LATIGO TRAILS FILING NO. 10 EL PASO COUNTY, COLORADO PUBLIC UTILITY PLANS

MSMD SECOND REVIEW

COVER SHEET

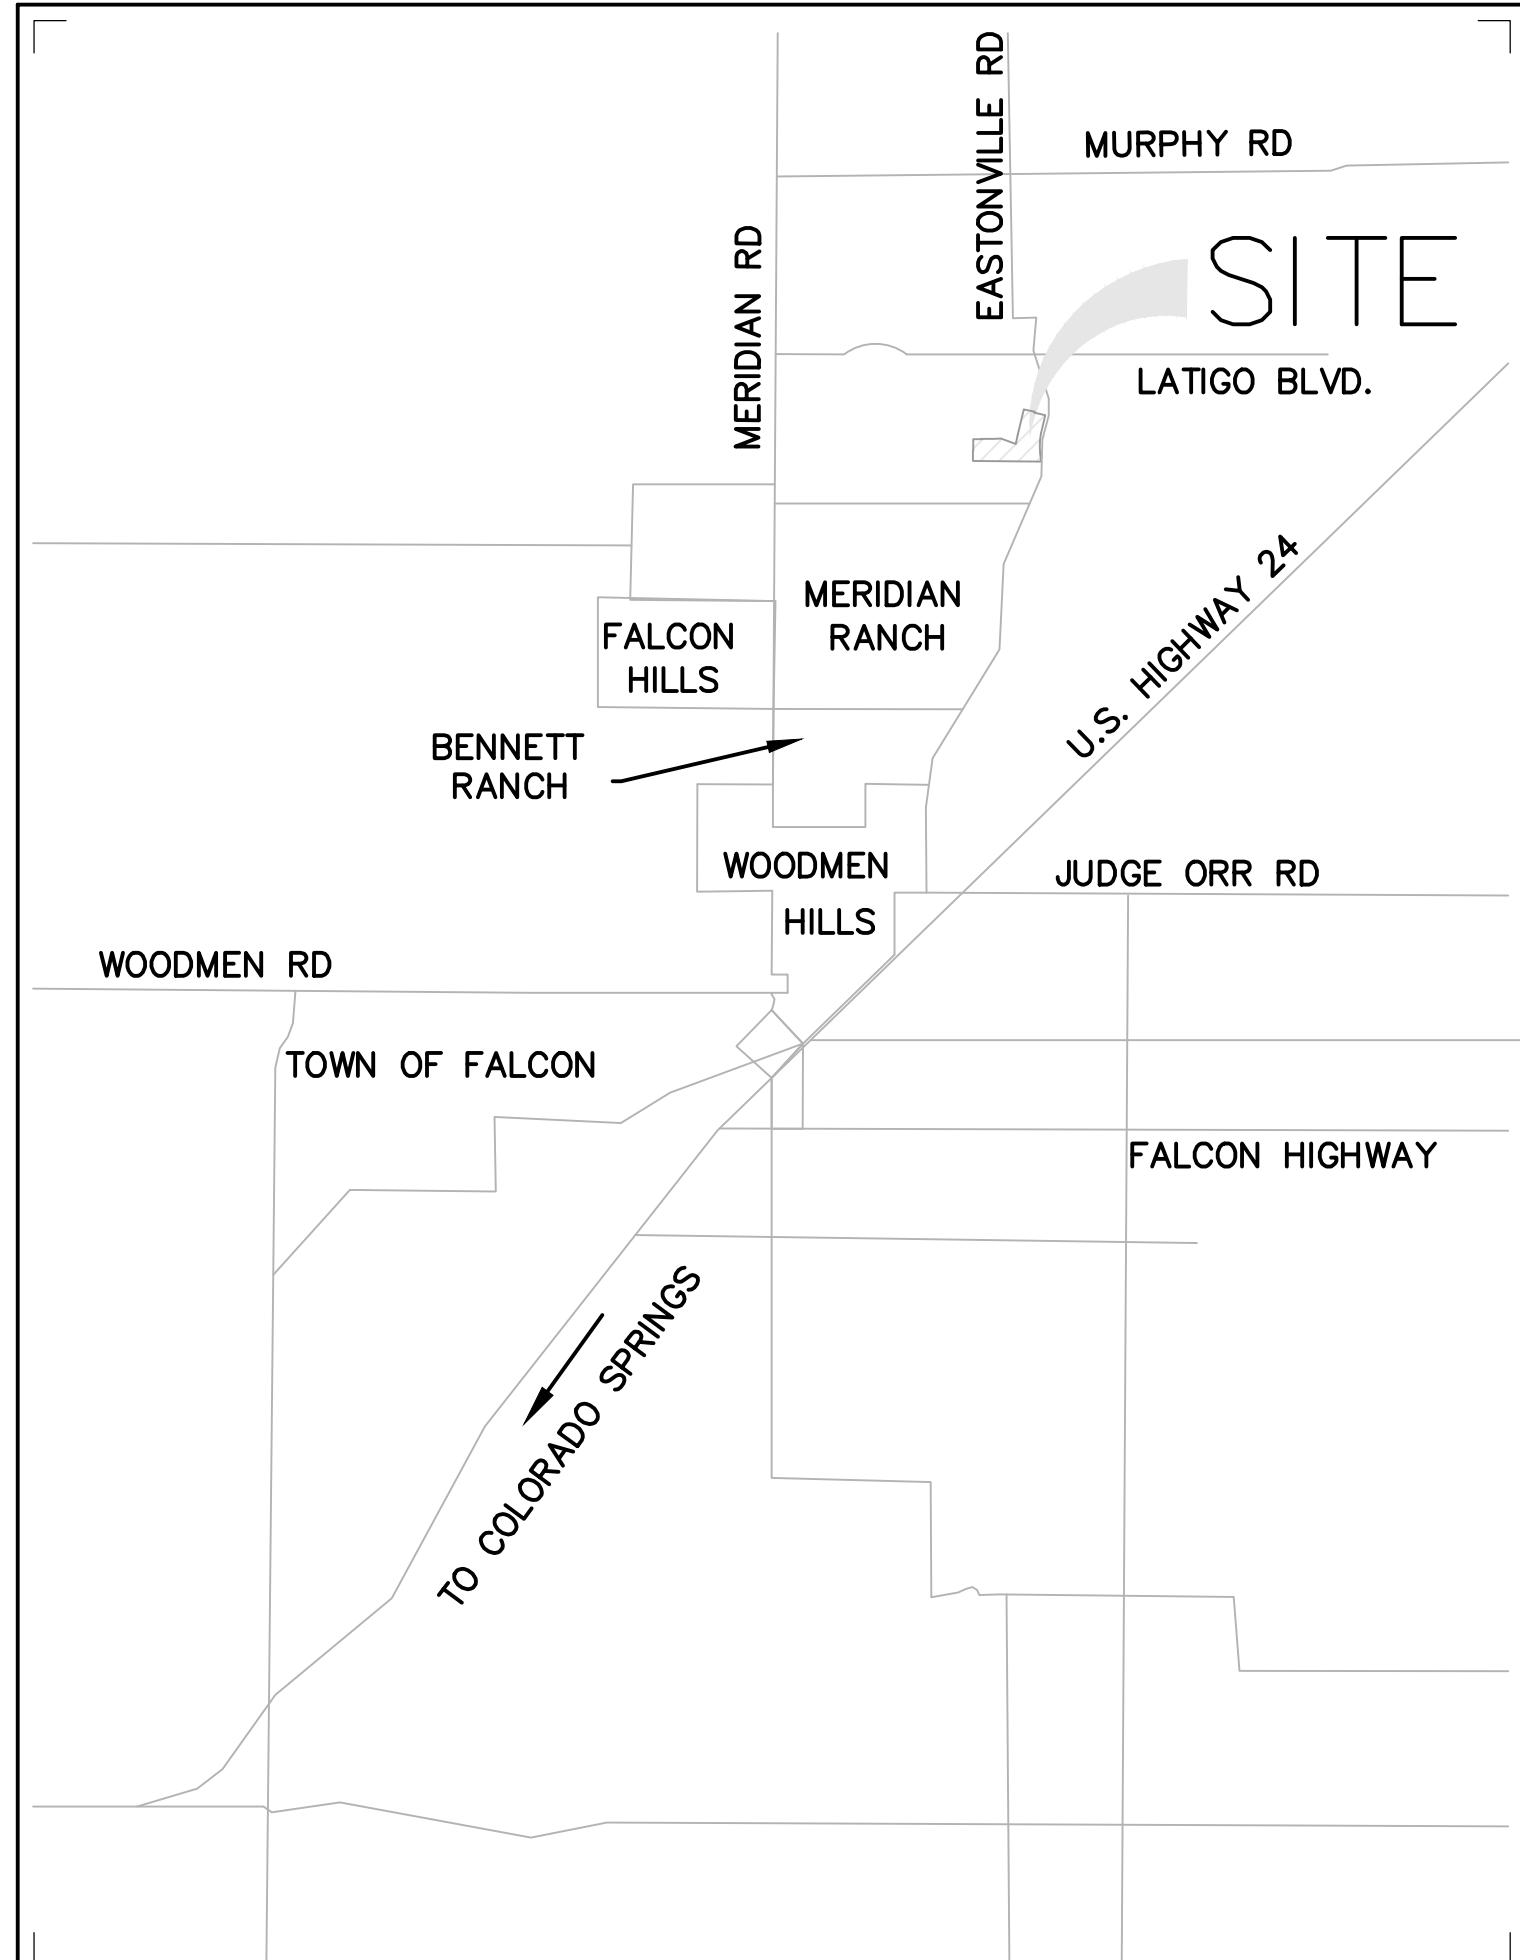
WATER INSTALLATION CORROSION CONTROL REQUIREMENTS: SEE PLAN FOR PLACEMENT WATER PLAN APPROVAL REMOVE SIGNATURE BLOCK SIGNED MERIDIAN SERVICE METRO DISTRICT WORK ORDER NUMBER PROJECT NUMBER DISTRICT ENGINEER DATE

**WATER SERVICE PLAN**

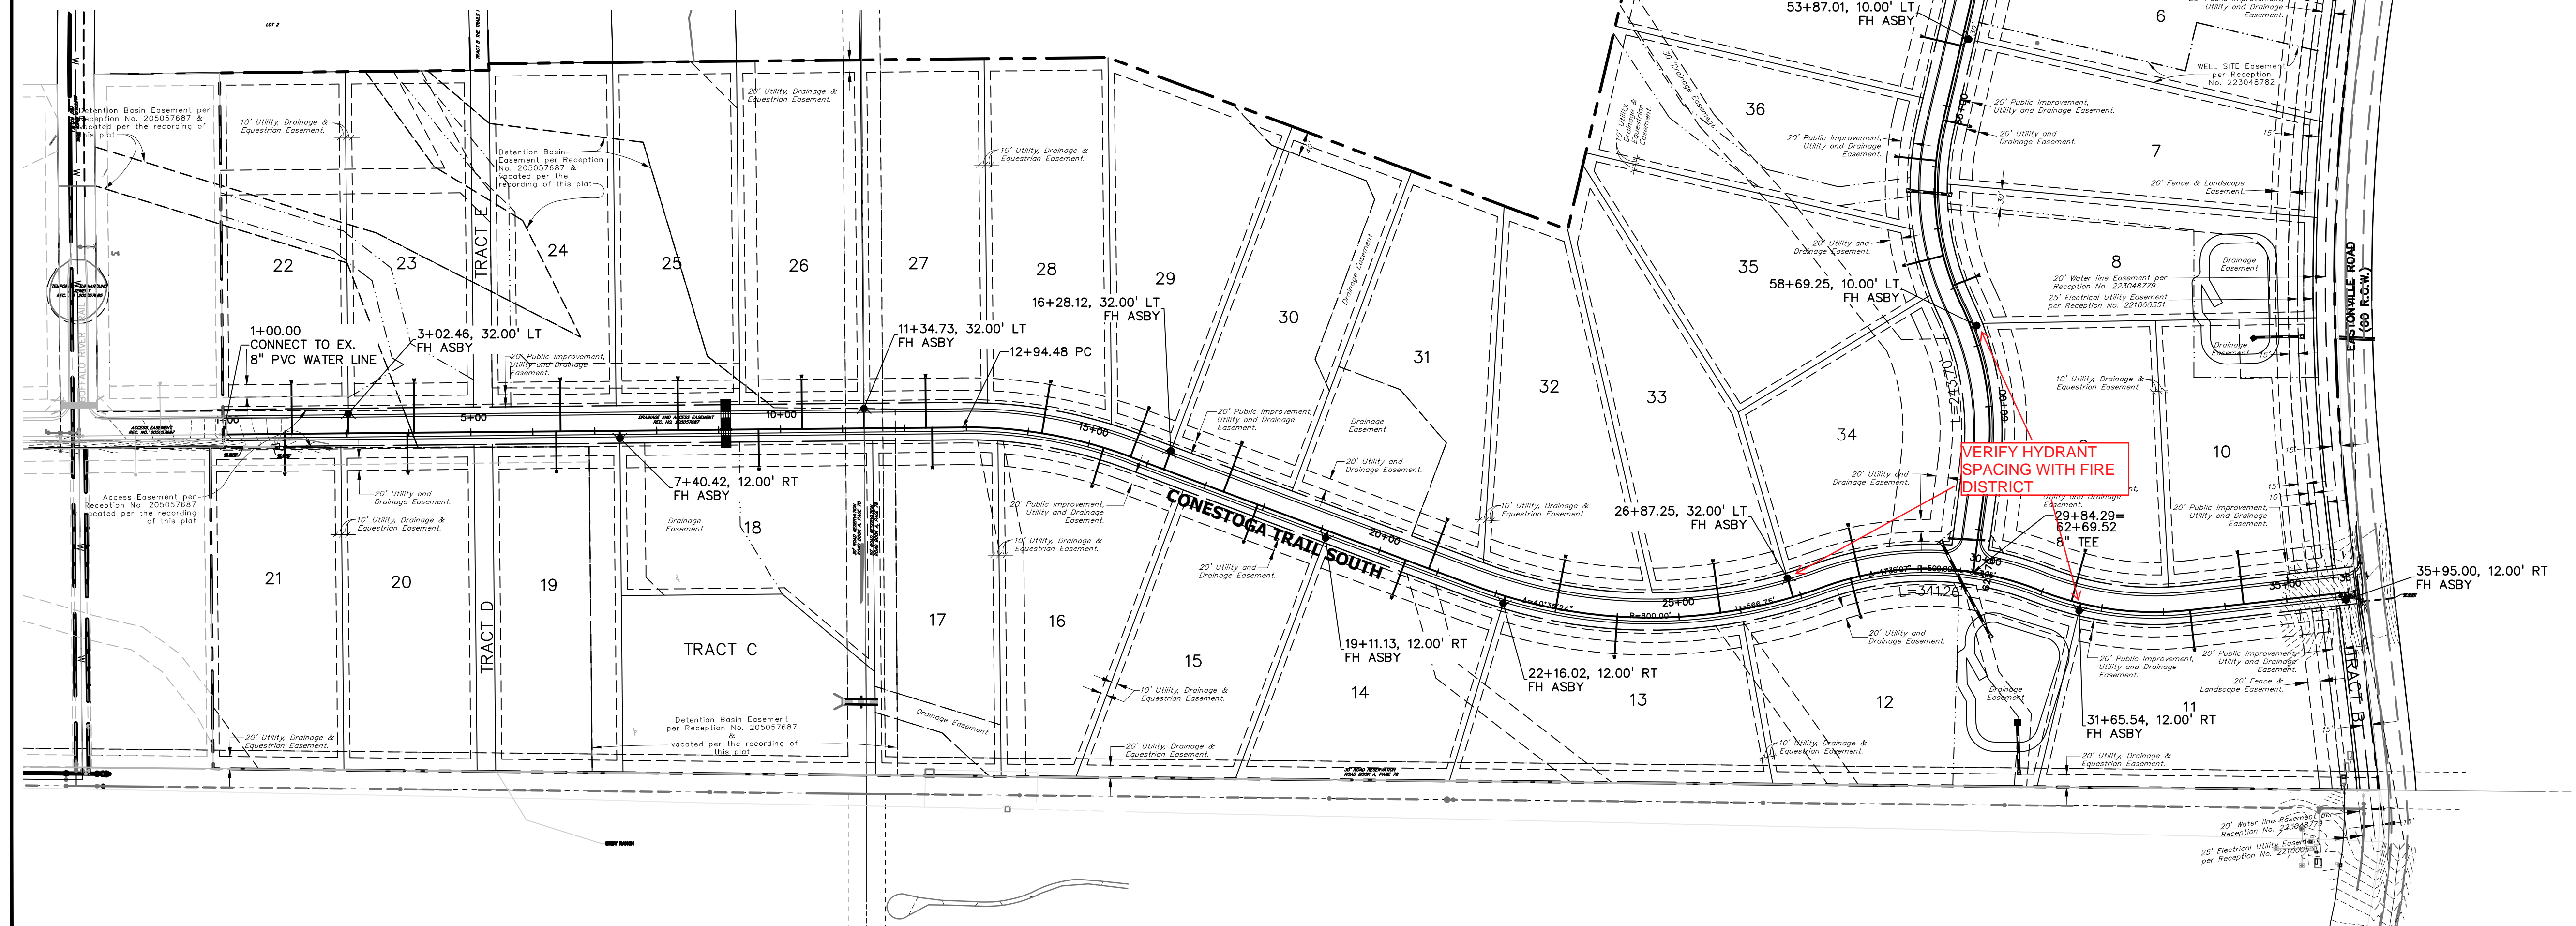
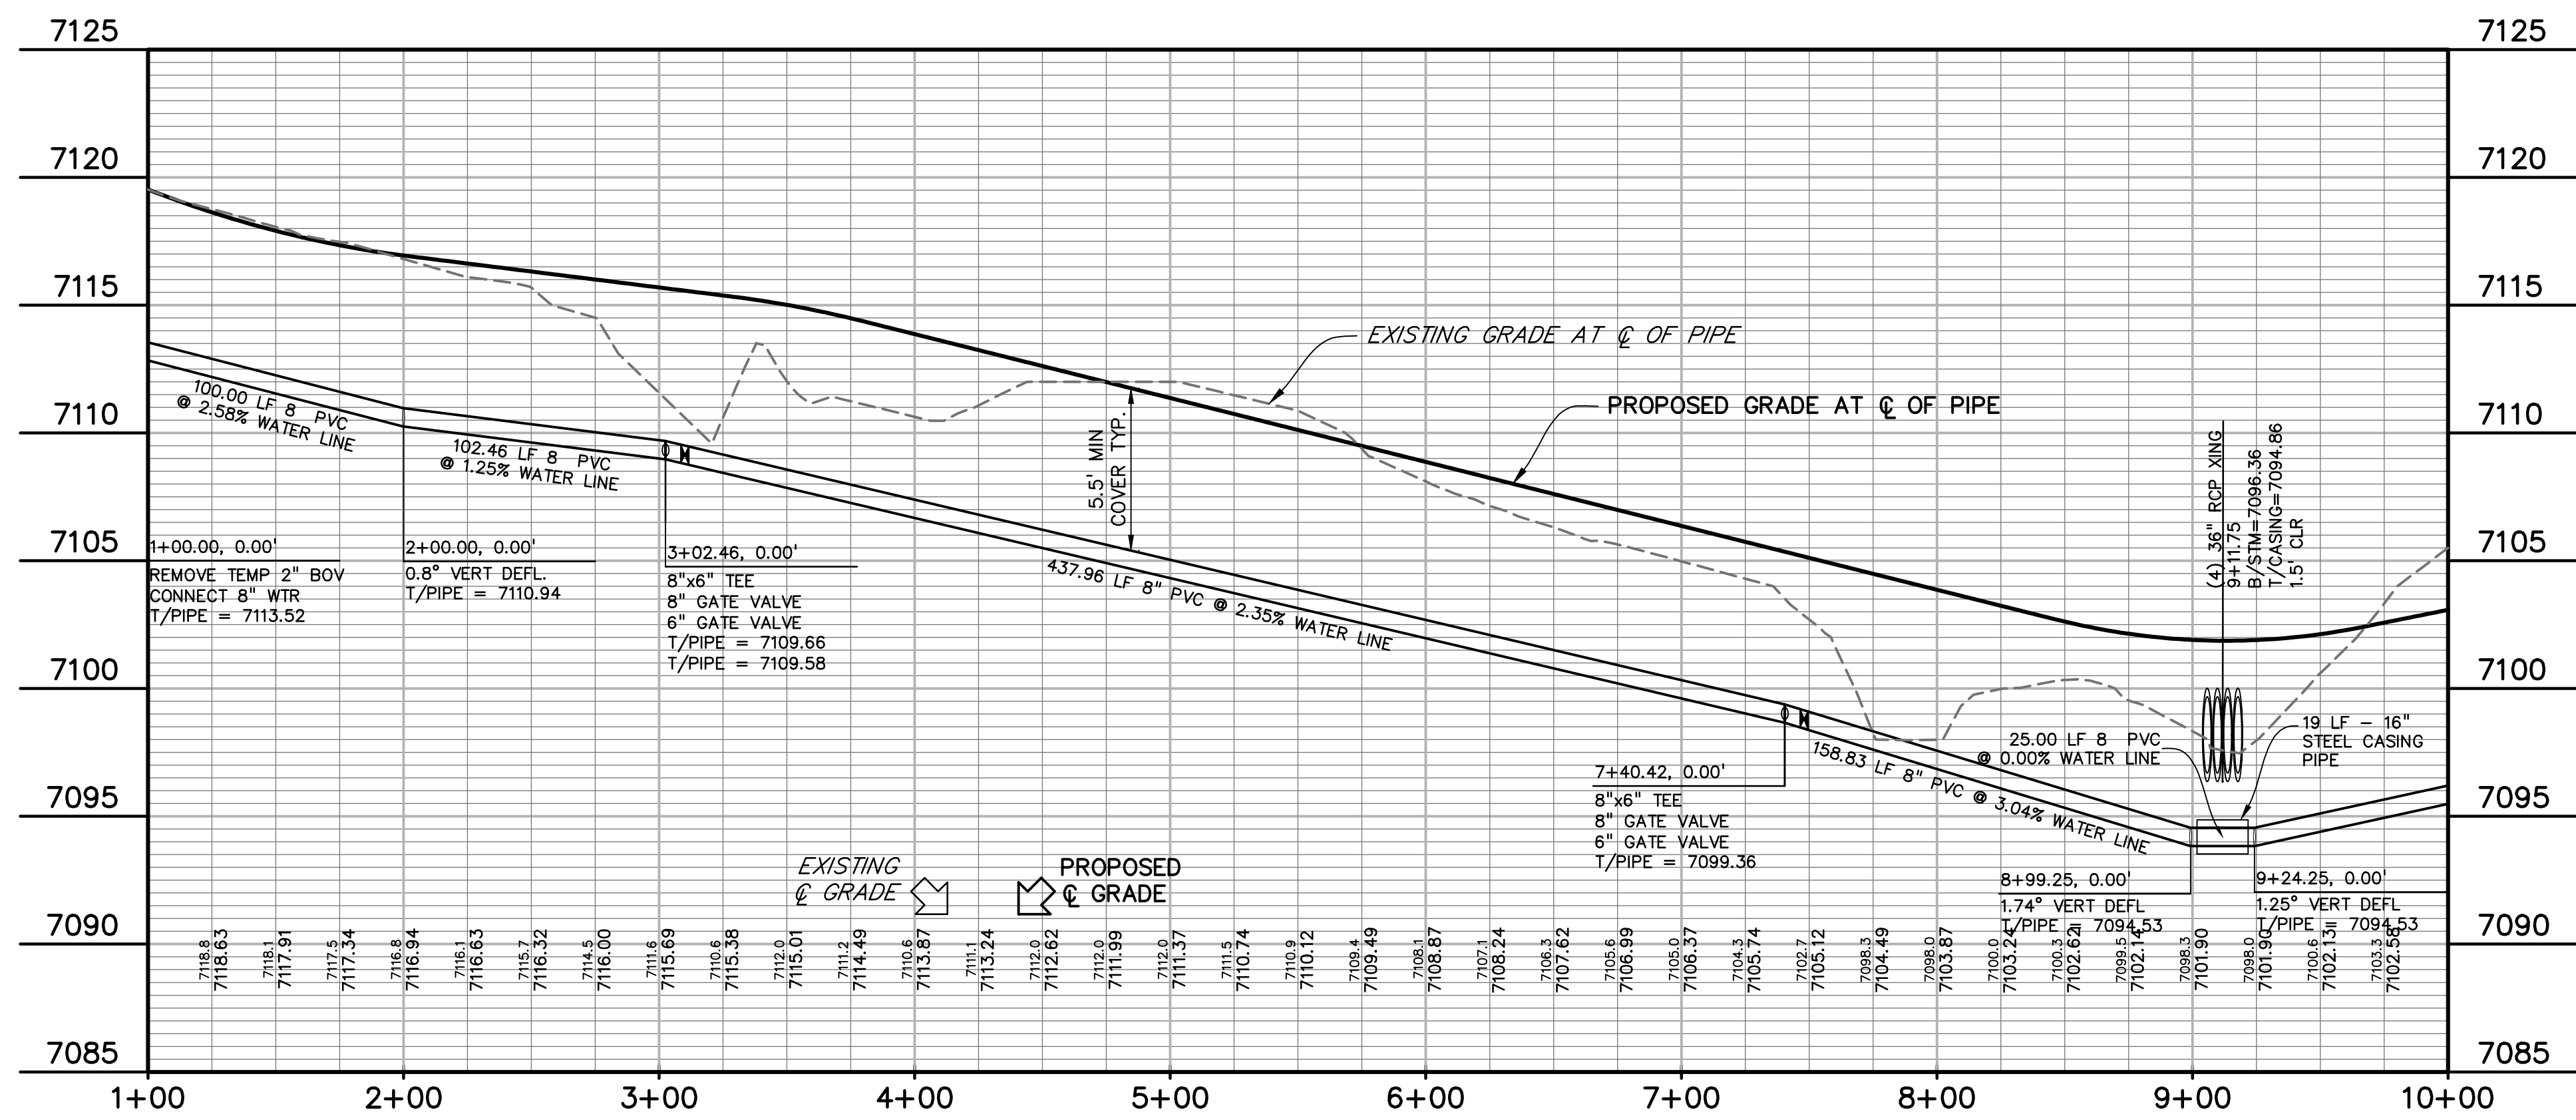
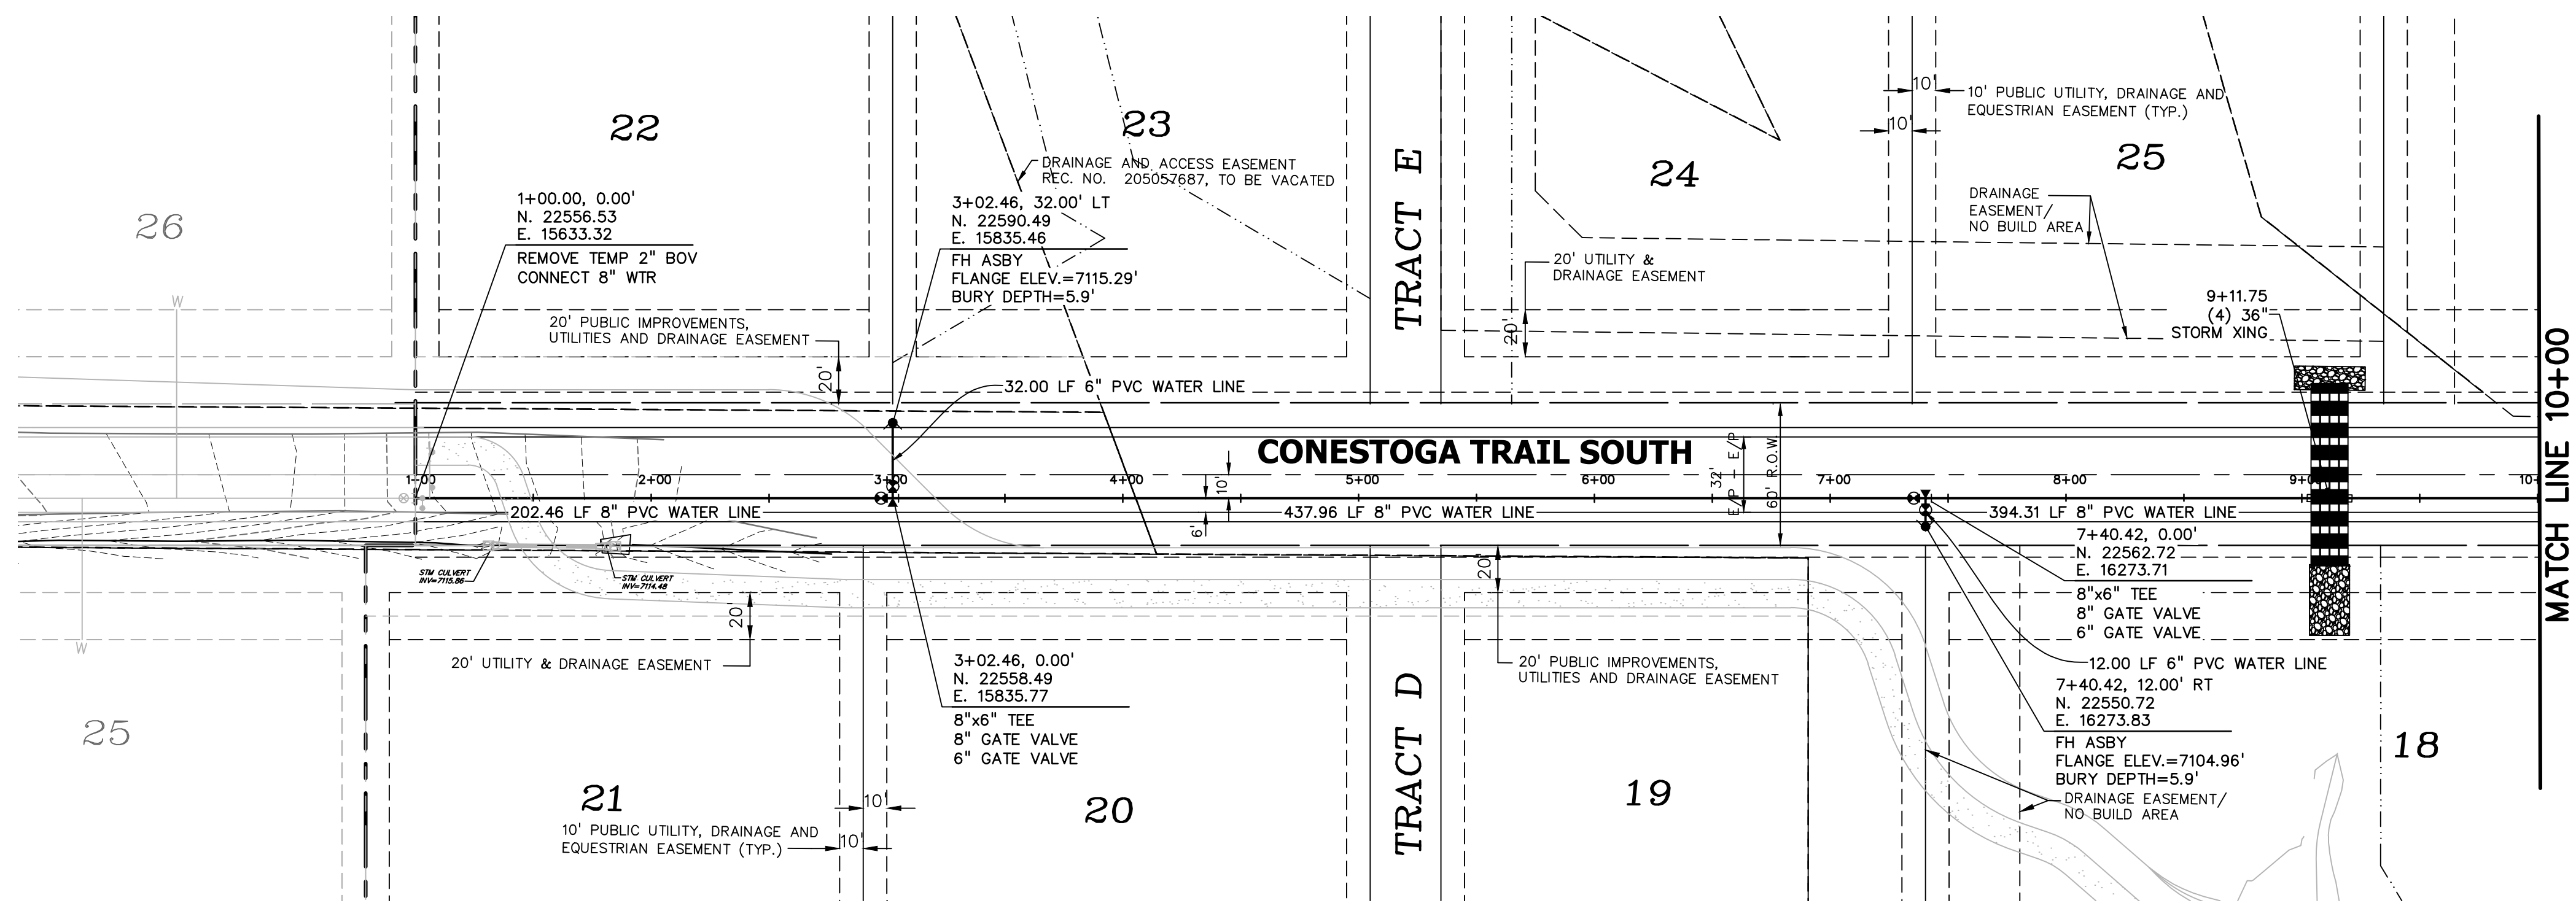
PROVIDE A TYPICAL CROSS-SECTION OF THE HYDRANT LOCATION FOR THIS PROJECT THAT MATCH THE PROPOSED STREET SECTION. I.E. WITHOUT CURB & GUTTER.
